13553  
15 December 2014

**18-22 OCEAN STREET NORTH AND 30 WELLINGTON STREET, BONDI  
PANEL REFERENCE 2014SYE115**

## **RE: 30 Wellington Street and 18 – 22 Ocean Street North Bondi Substation Location Requirements**

**Figure 1** – Extent of the 6m blast zone if the substation is located adjacent to Building A

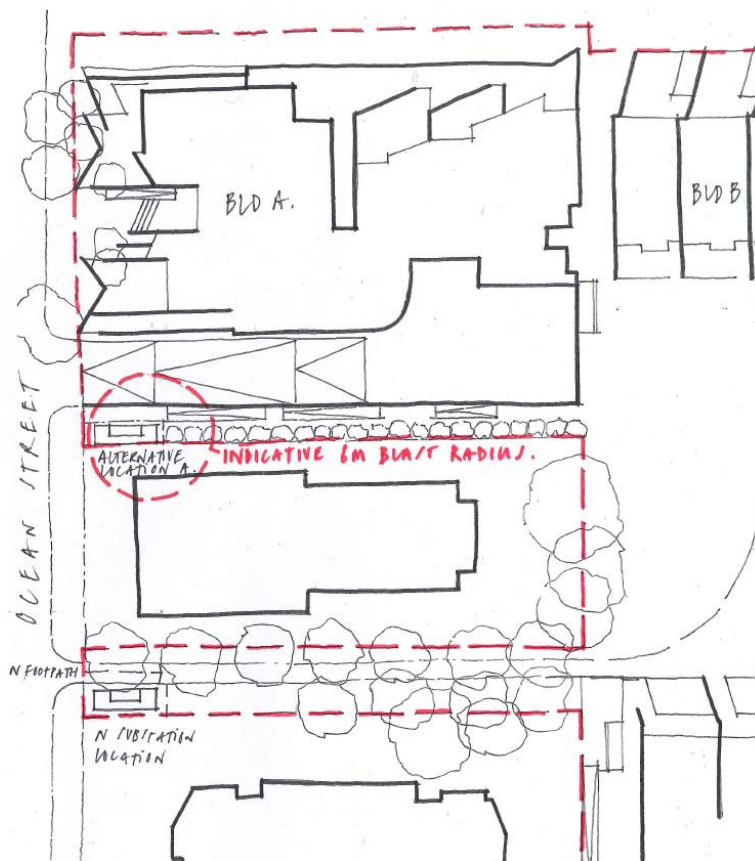
Mirvac maintains that the proposed location is the only suitable location for the proposed substation. This is supported by the statement prepared by Integrated Group Services (IGS) (submitted at Appendix H of the Amended DA submission, and **attached** for reference). IGS has been liaising with Ausgrid since before Mirvac acquired the site. IGS has reviewed the substation location, and in consultation with Ausgrid, has confirmed that the proposed location is the only suitable location for the substation for the following reasons:

- Mirvac were advised during due diligence that the substation was required to be located behind the property boundary on ground that is within a few hundred millimetres of the level of the existing road. There are only two locations on the site that meet this requirement, being the proposed location on Ocean Street North and the southern boundary of the site on Wellington Street. The southern boundary location has been discounted as it would require extensive trenching which would interfere with the Structural Root Zone of the heritage listed Norfolk Island Pine.

- The proposed location provides unobstructed level access for installation and ongoing maintenance in accordance with Ausgrid Network Standards.
- Options to incorporate the substation into the building were also discounted due to the adverse impact it would have on the design and architecture of the buildings as a result of Ausgrid's access requirements and the need to provide adequate blast proofing. Relocating the substation to the walkway alongside Building A was considered, however for safety reasons, the substation and any building openings to habitable space are required to be separated by more than 6m, which is not achievable in this location due to the proximity of the neighbouring property. The sketch at **Figure 1** indicates the 6m blast radius and the impact it would have on the neighbouring building. In addition, the opportunities to provide landscaping to screen the substation are more limited adjacent to the driveway entry. An example of the type of poor design outcome that would result from locating the substation adjacent to Building A is provided in **Figure 2**.

- Ausgrid's Contestability Manager has confirmed that the kiosk substation can be screened by hedges, shrubs, climbing plants and / or fences up to 2 metres tall to reduce the visual impact on the streetscape and through-site link, provided gates are supplied to provide adequate access. IGS has had a preliminary discussion with Aspect Studios and believe that an appropriate solution can be reached. An image indicating the type of screening that can be achieved has been prepared by Aspect Studios, and is provided at **Figure 3**.

**Figure 6** – View 2 looking towards Scarba House from Wellington Street (wall height 1.82m). This view will not be significantly impacted by Building C and would not be enhanced by any reduction to Building C.

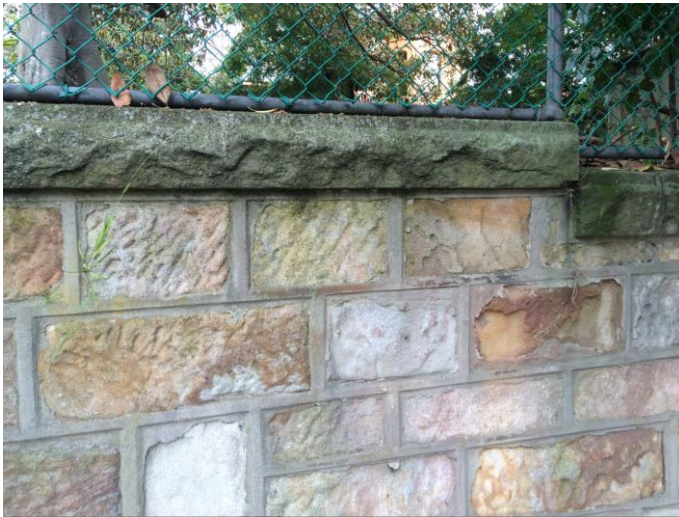
With reference to the elected Council's request to provide an additional setback to Building C to open views to Scarba House from Wellington Street, it is noted that the slope of Wellington Street, together with the height of the stone retaining wall, effectively prevents any additional views to Scarba House that would be created by an additional setback. This is demonstrated by **Figures 4 to 7**, which show the existing view at various points along Wellington Street. Views to Scarba House from Wellington Street are currently obscured by a later building, fencing and major trees. Removal of the modern building and poor quality fencing, and the revised positioning of Building C as currently proposed, will greatly enhance views to the historic house.

- **View 1** shows the primary view of Scarba House from Wellington Street, where the sandstone wall is 760mm high. This view will not be impacted by Building C, and would not be improved by any additional setback to Building C.
- **View 2** is from lower down Wellington Street where the wall is 1.82m high. From this location only the top of Scarba House can be seen. Notwithstanding this, any views to Scarba House are largely obscured by foliage from existing heritage trees, which are to be retained. Any amendment to Building C would not result in significant views from this location.
- **View 3** is in line with proposed Building C, and would be the only place where a pedestrian would obtain a visual benefit from an additional setback. At this location the wall is 2.06m high, and so no views are available to Scarba House.

**Figure 9** – Indicative sketch of the proposed wall opening on Wellington Street

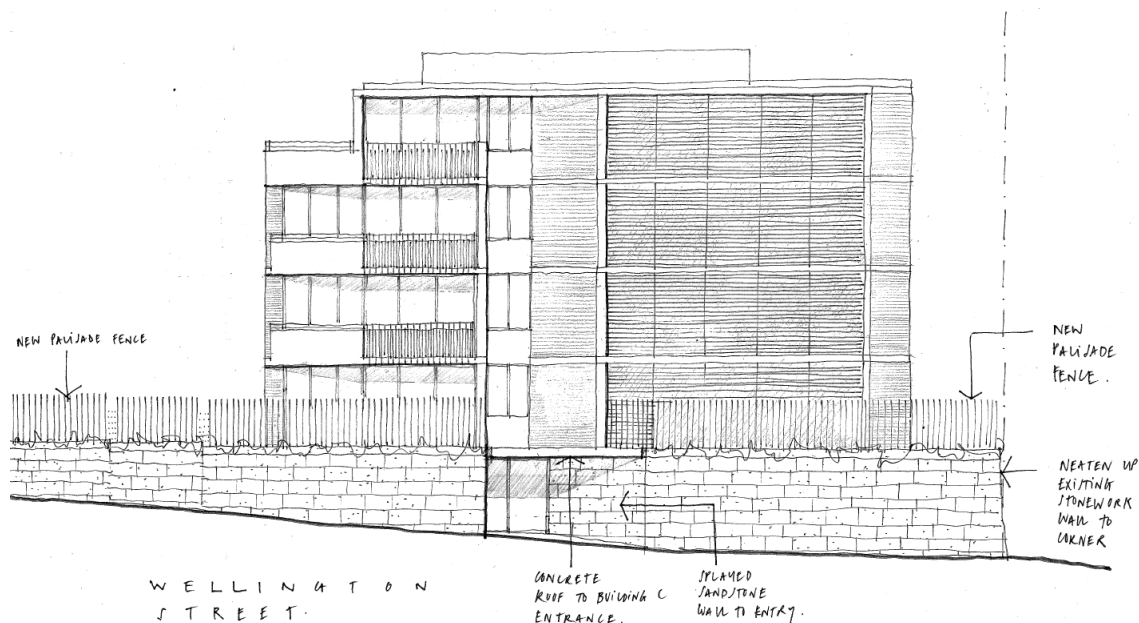
Draft Condition 5(e) requires that the opening in the sandstone wall in front of Building C on Wellington Street be deleted. In consultation with Smart Design Studio and Graham Brooks and Associates, it is proposed to delete this part of Condition 5(e) so that the wall opening can be retained. The proposed wall opening to accommodate a pedestrian entry is considered appropriate as it provides:

It is noted that due to the age of the existing sandstone wall, its current poor state of repair and the arrangement of the existing building immediately behind it, stabilisation works are required in this location. These works will have a visible component regardless of the design. Due to the presence of the existing opening in the sandstone in this section of the wall, the proposed entrance is considered a logical solution that will have the least visible impact when viewed from the public domain. The existing opening in the wall and its current state of repair are shown at **Figure 8**.

Finally, the entry has been designed as an attractive and distinctive component within the precinct's architectural family of buildings. As part of the design process Smart Design Studio has refined the proposal in consultation with Graham Brooks and Associates to provide for the reconstruction of the sandstone wall along one side of the entry portal extending within the site. A sketch of the proposed design is provided at **Figure 9**.

<p><b>Condition 5(c)</b></p> <p>No approval is granted for an opening in the sandstone wall for Building C access directly from Wellington Street. In this regard, the sandstone wall shall be retained as existing (and restored) and the opening deleted from the plans. The plans shall be amended to setback 'B1 Basement Plan level' of Building C a minimum of 1.5m from the eastern boundary of the site. Accessible entry/exit shall occur at ground level.</p>	<p><b>Condition 5(c)</b></p> <p><del>No approval is granted for an opening in the sandstone wall for Building C access directly from Wellington Street. In this regard, the sandstone wall shall be retained as existing (and restored) and the opening deleted from the plans. The plans shall be amended to setback 'B1 Basement Plan level' of Building C a minimum of 1.5m from the eastern boundary of the site. Accessible entry/exit shall occur at ground level.</del></p>	<p>The opening in the Wellington Street wall is required to provide a sense of address to Building C. The opening seeks to enhance an existing opening, and will not significantly alter the reading of the wall from Wellington Street. The proposed opening is supported by the project's heritage consultant.</p> <p>Further justification and explanation for this proposed change is provided at Section 3.0 of this response.</p>

Figure: 1 – Ausgrid's 11kV network surrounding the development site

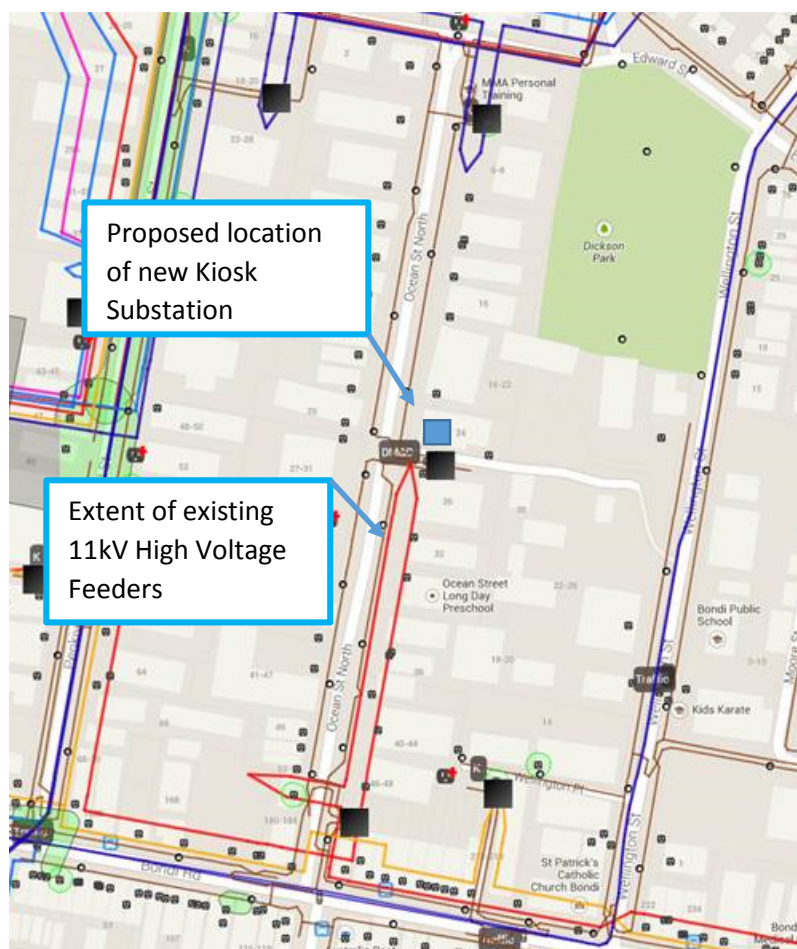
Due to the size of the development, the site is required to be serviced by an 11kV underground cable. Figure 1 below depicts Ausgrid's 11 kV network (in red) surrounding the development site. As indicated by the diagram, the 11kV high voltage network does not extend any further north past the existing kiosk substation located at 26 Ocean Street Bondi and there is no high voltage network on Wellington Street whatsoever. The proposed location has been carefully assessed and negotiated with Ausgrid's Contestability Manager, Doug Chalker to ensure the site can be adequately serviced from Ausgrid's Network. This is evidenced by the Deed prepared by Ausgrid attached to this letter which shows the design of the substation on Ocean Street North.
